MECKLENBURG COUNTY
DEPARTMENT OF ENVIRONMENTAL HEALTH

APPLICATION FOR SOIL INVESTIGATION

APPENDIX II
SITE EVALUATION

SITE INVESTIGATION REPORT
INDIVIDUAL SEPTIC TANK SYSTEM
WITH SUBSURFACE,
SOIL ABSORPTION,
EFFLUENT DISCHARGE

* See Diagram on Back (Include: Soil areas, property lines, roads, streams, gullies wet areas, fill areas, wells, water bodies, slope patterns, etc.

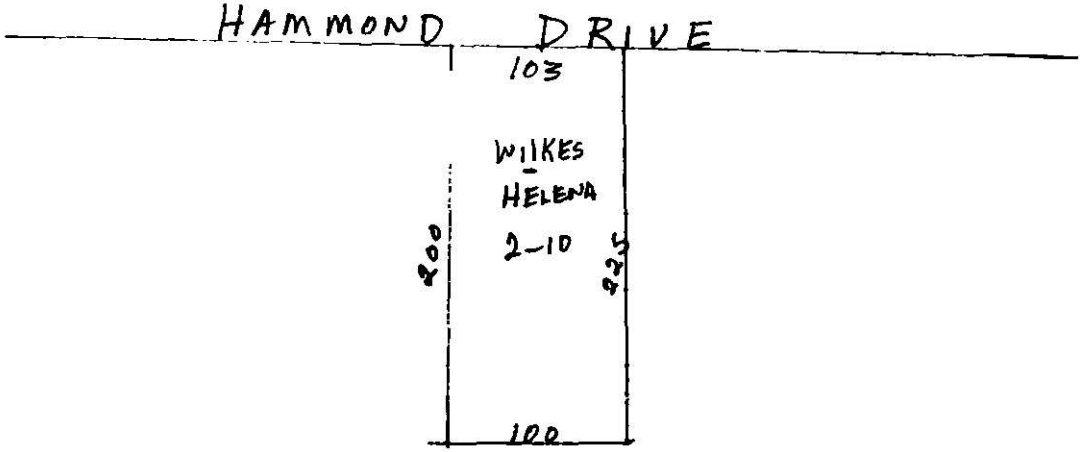
FACTORS		AREA 1	AREA 2	AREA 3	AREA 4
1. SLOPE (%)	S / (PS) / U	2-10	PS	PS	PS
2. SOIL TEXTURE (12-36 in.) (Sandy, loamy, clayey, Note 2-1. Clay)	S / (PS) / (U)	2-1 Clay Mixed	PS	PS	PS
3. SOIL STRUCTURE (12.36 in.) (Clayey Soils)	S / PS / (U)	Massive	PS	PS	PS
4. SOIL DEPTH (In.)	S / PS / (U)	<48	PS	PS	PS
5. RESTRICTIVE HORIZONS (In.) (Impervious Strata, Rock)	S / PS / (U)	Clays	PS	PS	PS
6. SOIL DRAINAGE/GROUNDWATER (External & internal)	S / PS / (U)	Slow	PS	PS	PS
7. SOIL PERMEABILITY (Percolation Rate)	S / PS / (U)	Slow	PS	PS	PS
8. OTHER (Specify)	S / PS / U		PS	PS	PS
9. SITE CLASSIFICATION		Unsuitable			
SOIL SERIES		WILKES HELENA

As determined under the Rules and Regulations promulgated by the Commission for Health Services, Division of Health Services, North Carolina Department of Human Resources, Raleigh, North Carolina, the soils on the lot described above were found to be unsuitable for the installation of an individual septic tank - soil absorption system, due to the following reason:

Soil Structure Massive

Soil Permeability Unsuitable
